# Access Compliance Report

## Public Rights-of-Way

### (Curb Ramps)

Intersection ID: 29294	Main Street: LOOKING_GLASS_LN	Cross Street: FAR_WEST_DR	Location: SE
ADA ID: E9F003D802D8	Ramp Type: PerpDiag	Initial Pass/Fail: Fail	Overall Compliance: No
Severity Score: 22.5			
Codes/Mitigation Info/Possible Solution		Field Measurements/Component Compliance

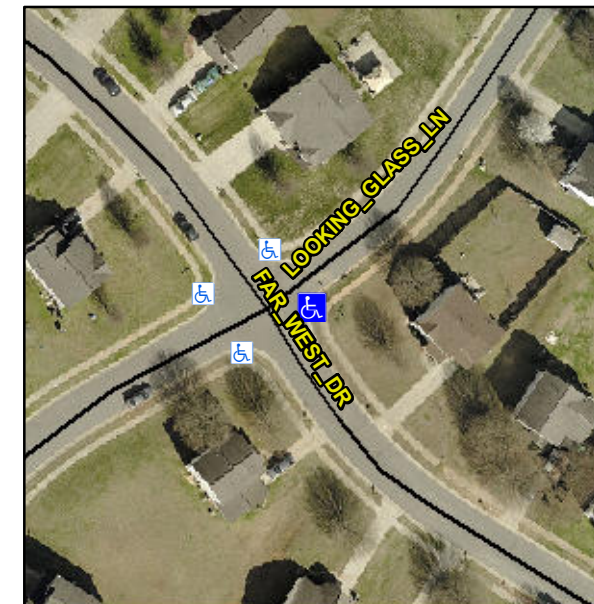
**R304.5.1, R304.2.2, R304.5.3**

Compliance	Description	Data	Compliance	Description	Data
N/A	Ramp Length (in)	55.0	No	Ramp Slope (%)	11.1
No	Ramp Width (in)	41.5	No	Ramp XSlope (%)	2.1
N/A	Flare Type LT	N/A	N/A	Flare Type RT	N/A
N/A	Flare Slope LT (%)	N/A	N/A	Flare Slope RT (%)	N/A
N/A	Flare Traversable LT?	N/A	N/A	Flare Traversable RT?	N/A
N/A	Landing Length (in)	N/A	N/A	DWS Provided?	N/A
N/A	Landing Width (in)	N/A	N/A	DWS Contrast?	N/A
N/A	Landing Slope (%)	N/A	N/A	DWS Length (in)	N/A
N/A	Landing X Slope (%)	N/A	N/A	DWS Full Width?	N/A
N/A	Landing Curb? (Y/N)	N/A	N/A	DWS Offset (in)	N/A
N/A	Shared Landing?	N/A			
N/A	Gutter Ponding?	N/A	N/A	Gutter Slope (%)	N/A
N/A	Gutter Lip Ht (in)	N/A	N/A	Gutter X Slope (%)	N/A
N/A	Painted X Walk1?	No	N/A	Painted X Walk2?	No
	X Walk 1 Direction	To N		X Walk 2 Direction	To W
N/A	X Walk 1 Width (in)	N/A	N/A	X Walk 2 Width (in)	N/A
	X Walk 1 Slope (%)	3.2		X Walk 2 Slope (%)	0.2
	X Walk 1 X Slope (%)	0.1		X Walk 2 X Slope (%)	3.2

**Remove & Replace Curb Ramp With Two New Directional Ramps or Equivalent.**
